PARKER AND PINE FILING NO. 1 LOT 2 – SITE PLAN

3RD SUBMITTAL 10/05/2020

COVER SHEET
 MURPHY EXPRESS
 12405 SOUTH PARKER ROAD
 PARKER
 COLORADO

SHEET NO. C-3.5

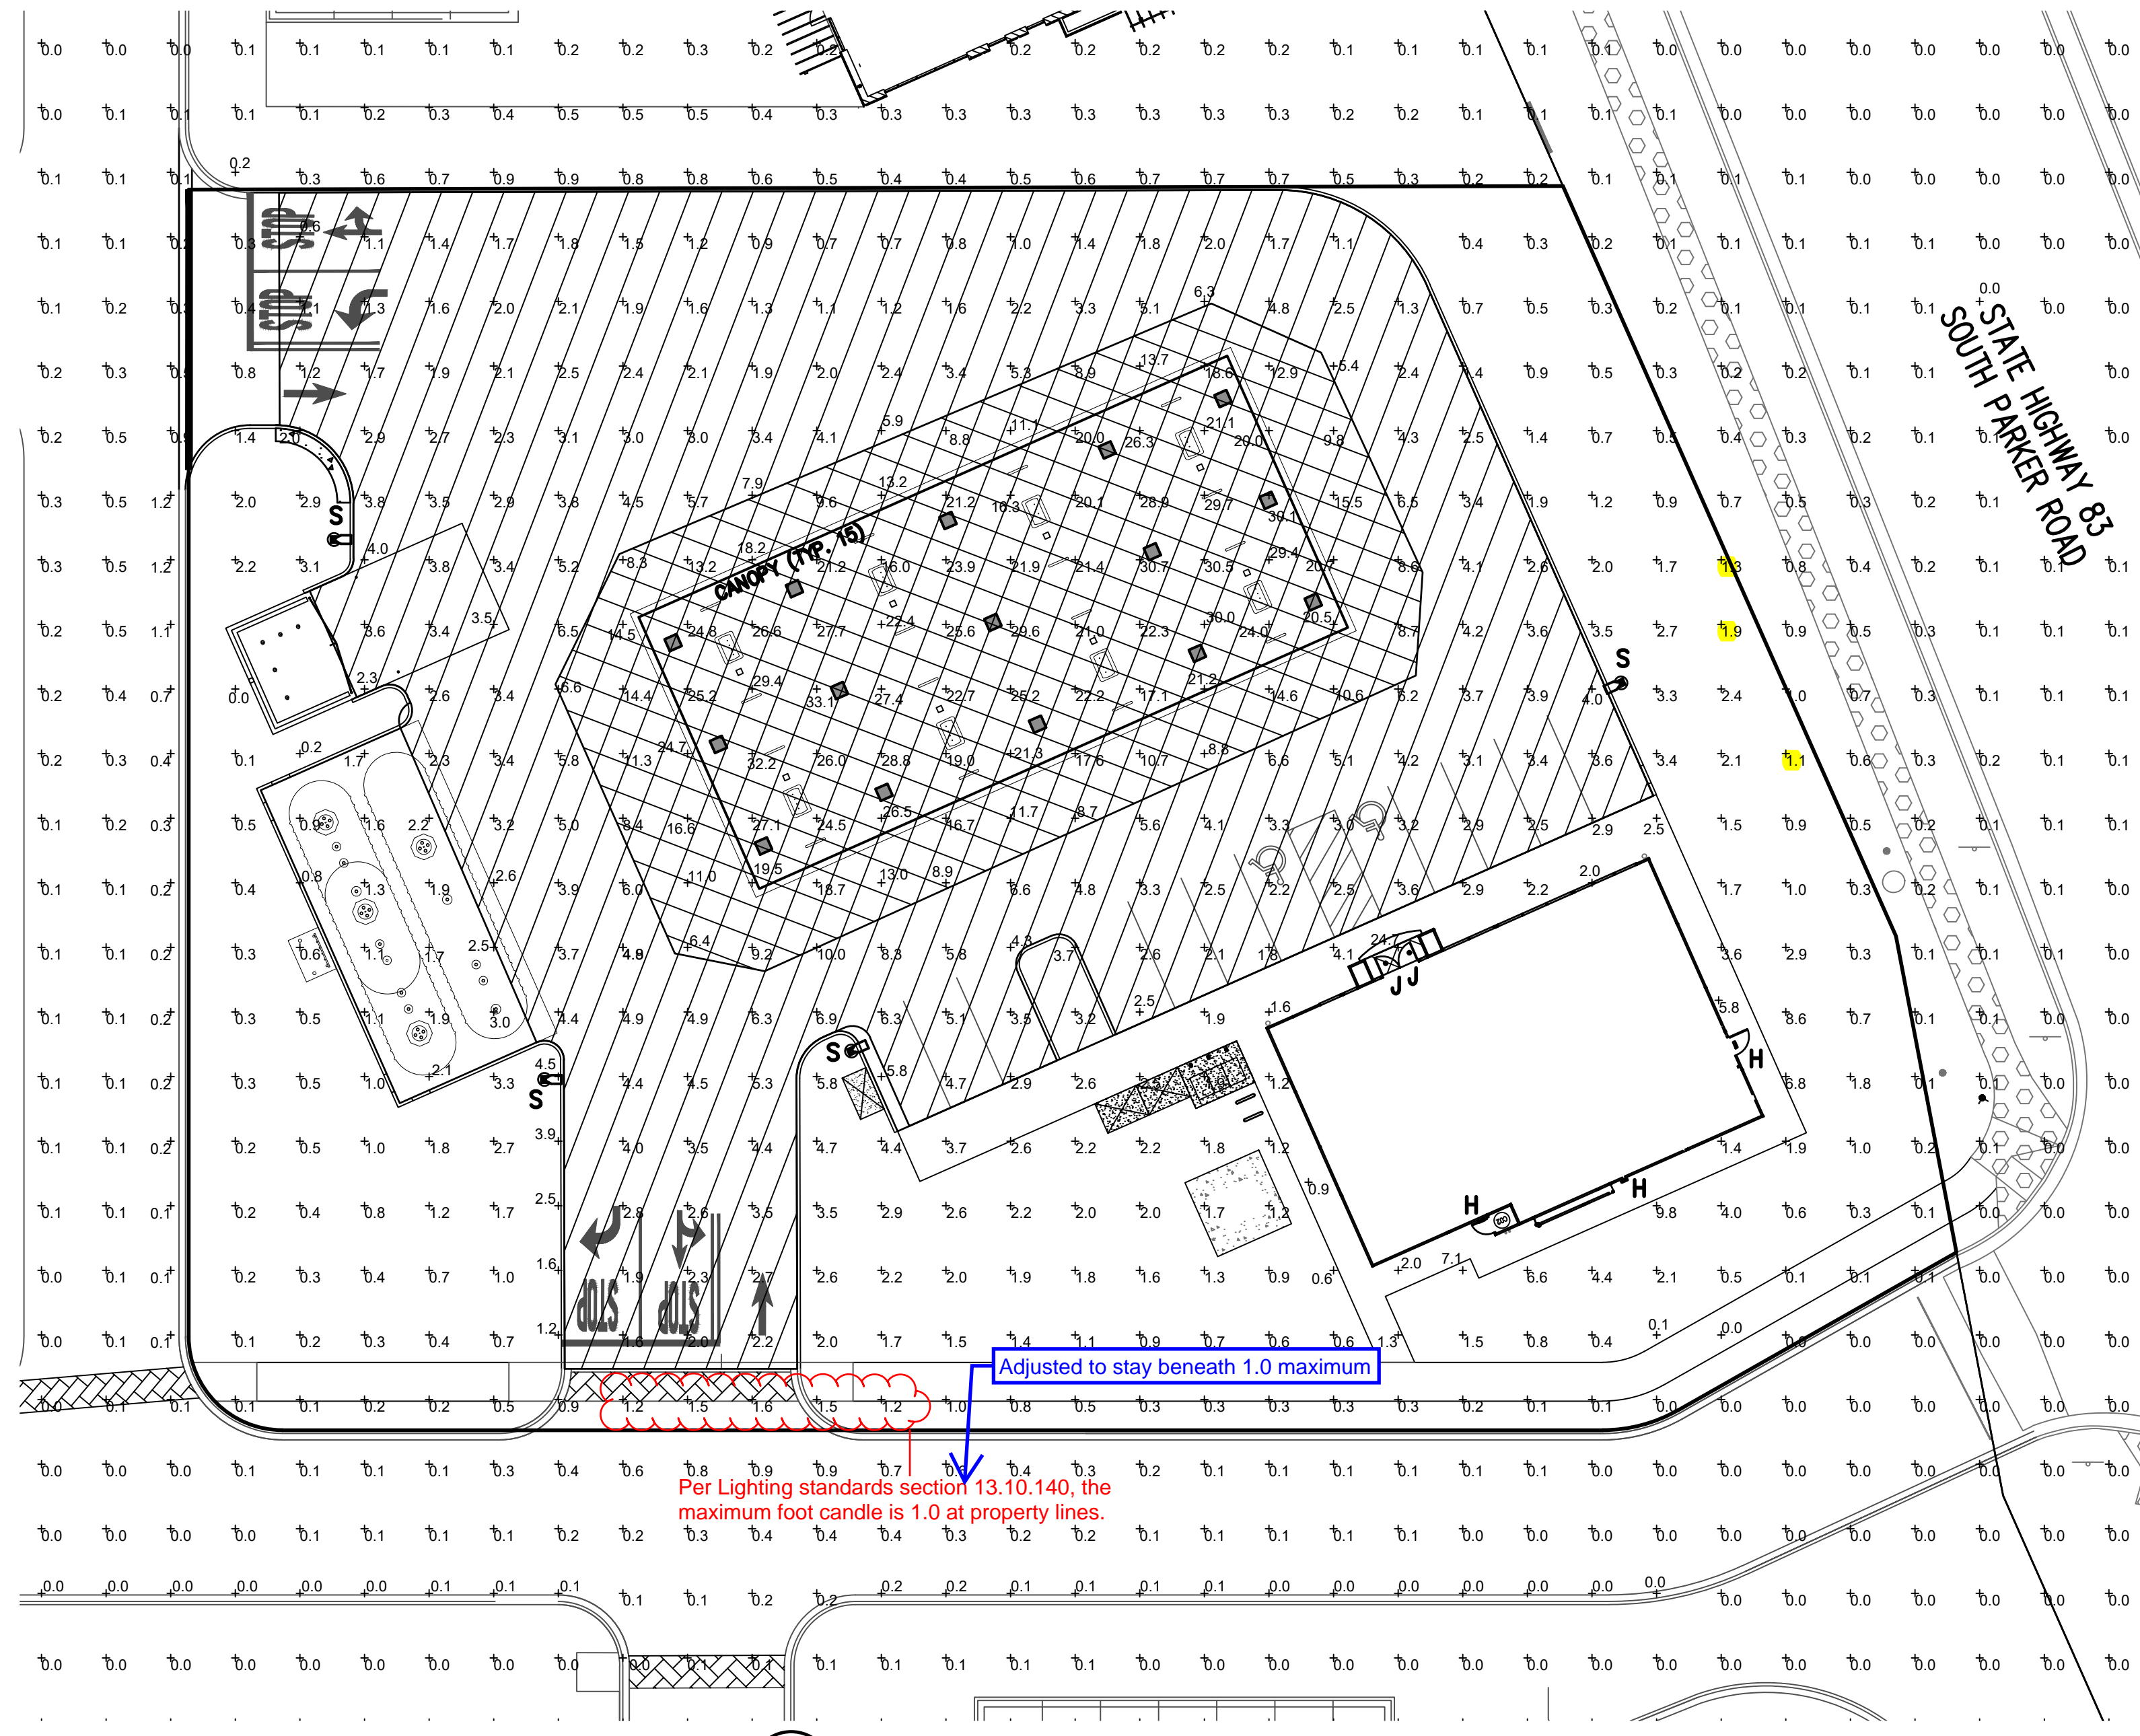
Lighting cannot exceed the height of the building (18.5').

Max height updated.

SHEET NO. **L1.1**

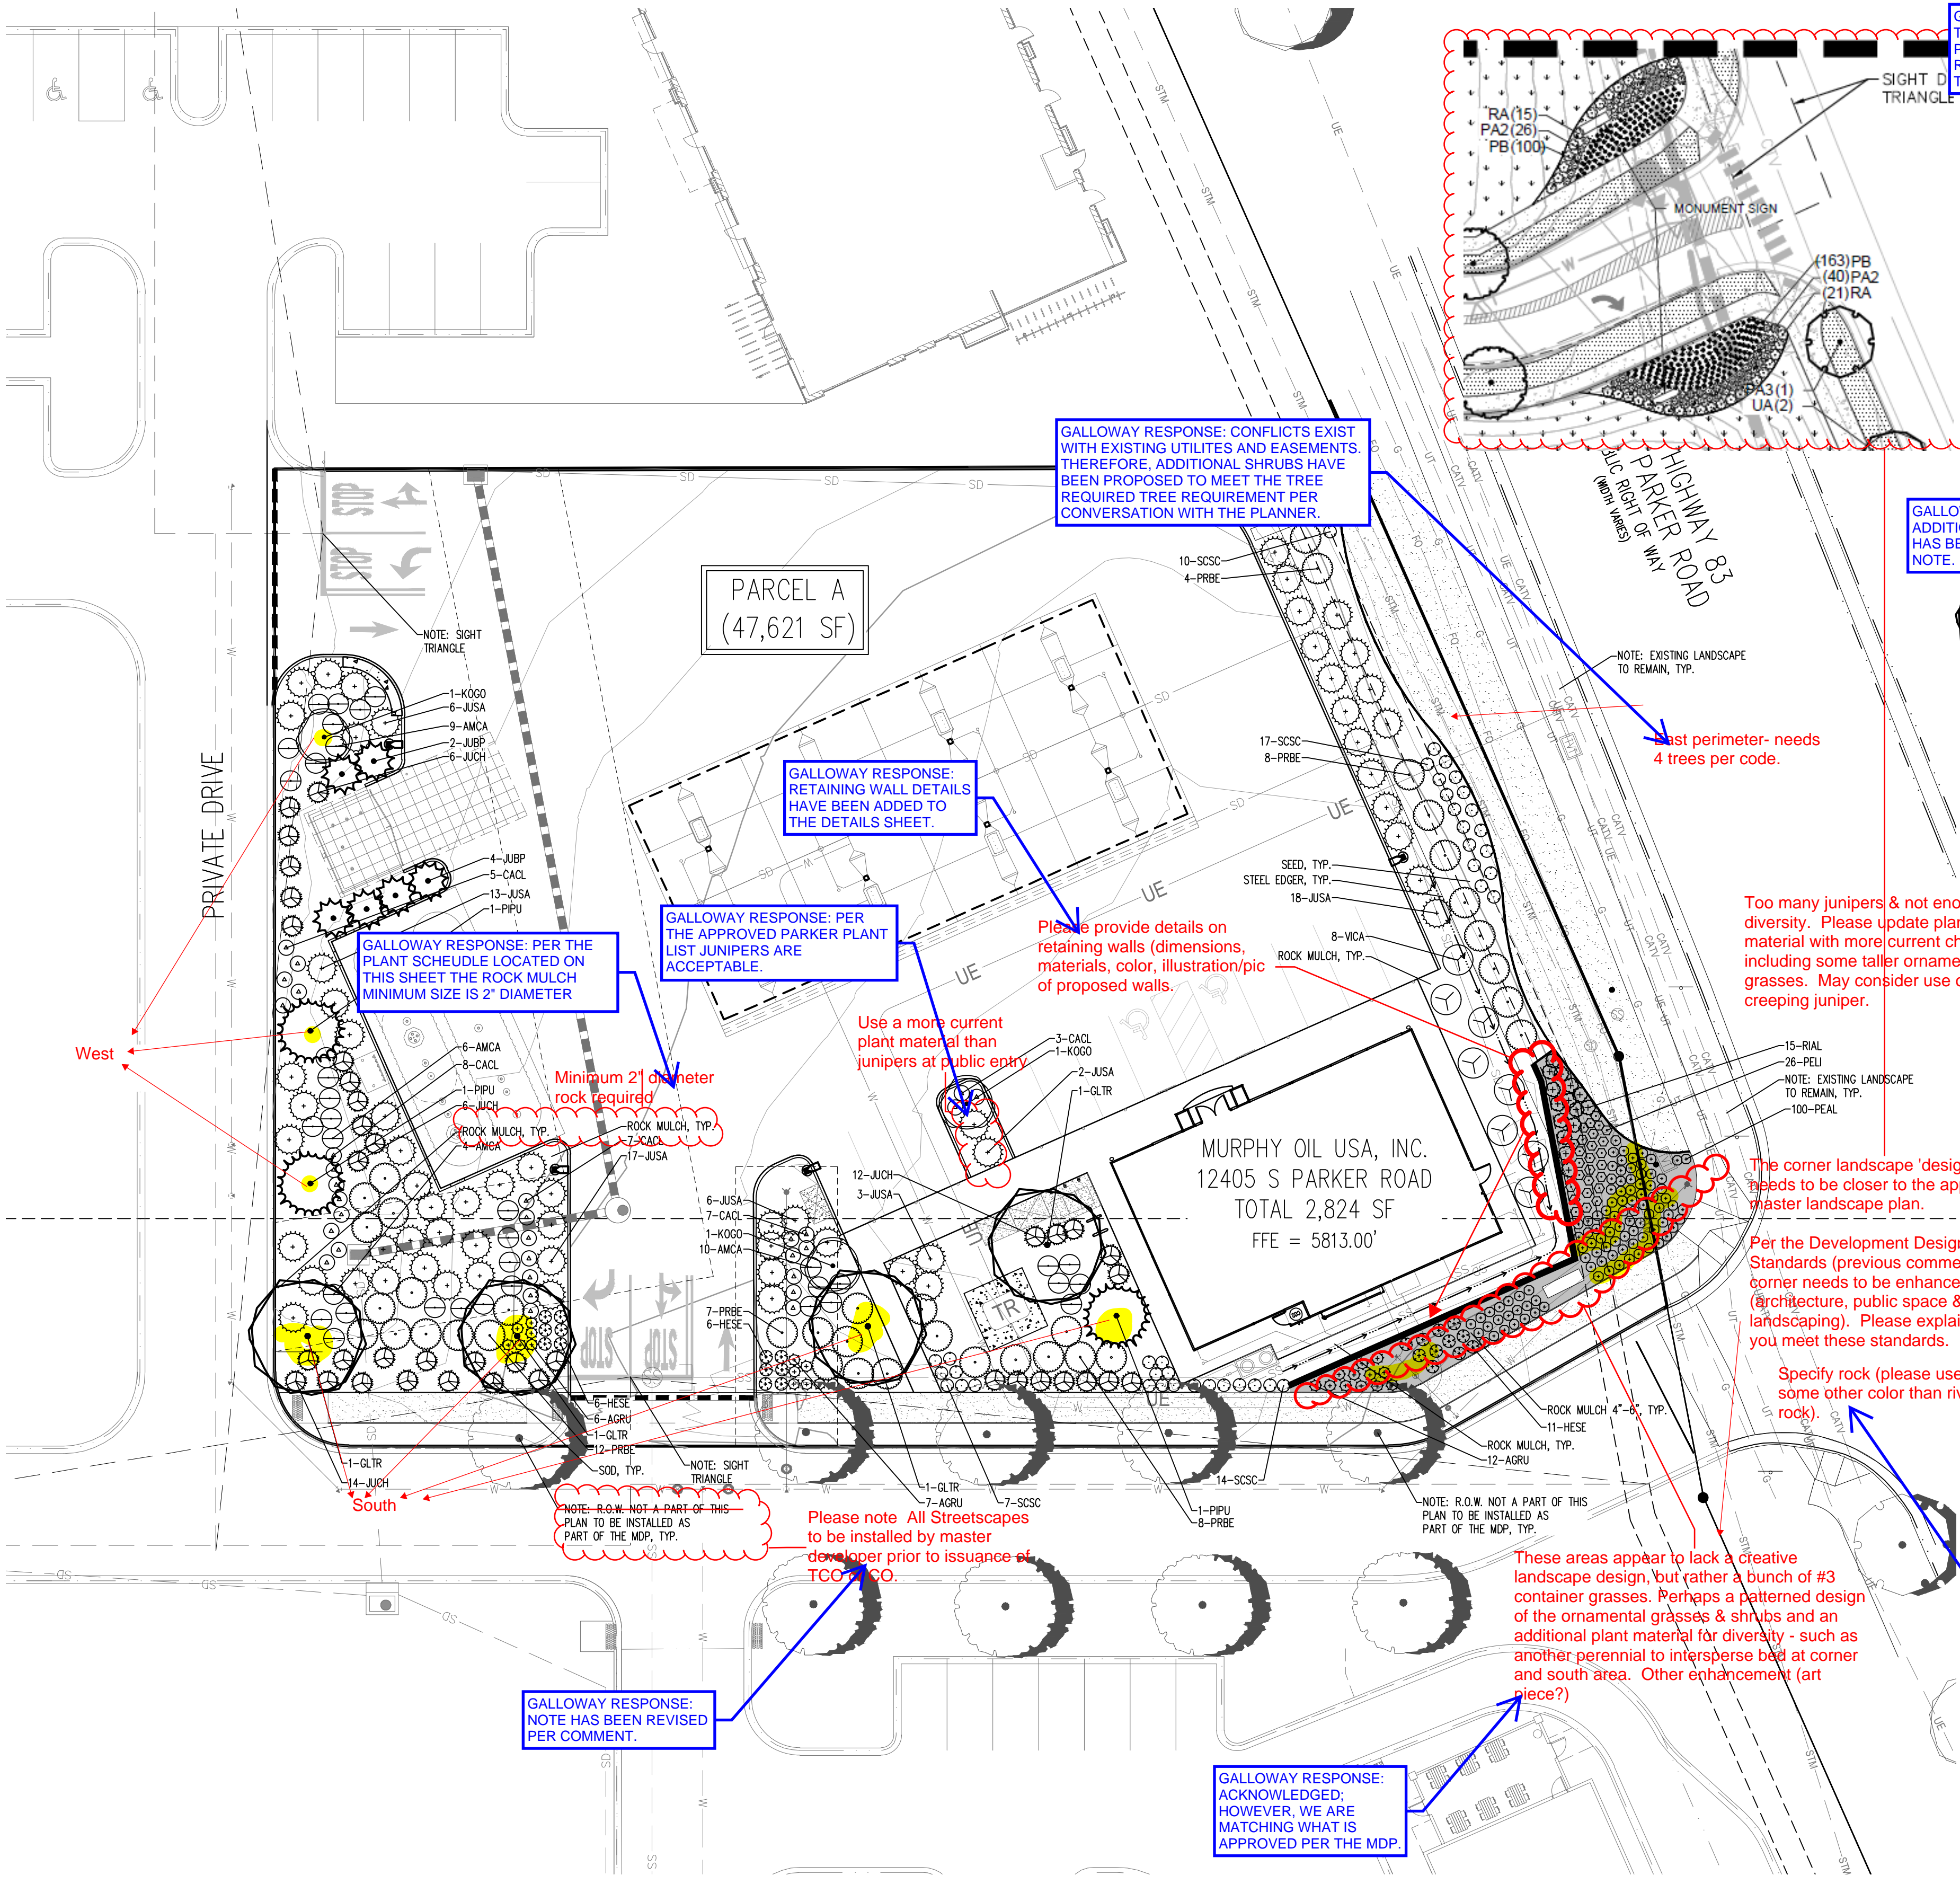
The south perimeter landscape requirement is separate from the required Streetscape (master developer to install). You are required to provide the south perimeter landscaping. Please add these trees & shrubs.

Please add: Any & all substitutions MUST be approved by the Town prior to installation.

No trees provided on East elevation of lot. Please add.

Only 4 trees provided on south perimeter (3 Locust & 1 Spruce). Please add 2 more trees. Also, per Review 2 comments please ensure these are located 5'-10' within property line. The other Locust is considered an interior tree (near building)

GALLOWAY RESPONSE: ACKNOWLEDGED, PER A PREVIOUS REVIEW GALLOWAY RECEIVED A COMMENT STATING TO ADD A NOTE TO THE TABLE. SEE SNIPPET RIGHT.

GALLOWAY RESPONSE: PER SECTION 13.06.070.(C) OF THE PARKER CODE THE SIX TYPES OF REQUIRED LANDSCAPING DOES NOT INCLUDE AN 'OVERALL REQUIRED LANDSCAPING' THIS ROW HAS BEEN REMOVED.

GALLOWAY RESPONSE: CONFLICTS EXIST WITH EXISTING UTILITIES AND EASEMENTS. THEREFORE, ADDITIONAL SHRUBS HAVE BEEN PROPOSED TO MEET THE TREE REQUIRED TREE REQUIREMENT PER CONVERSATION WITH THE PLANNER.
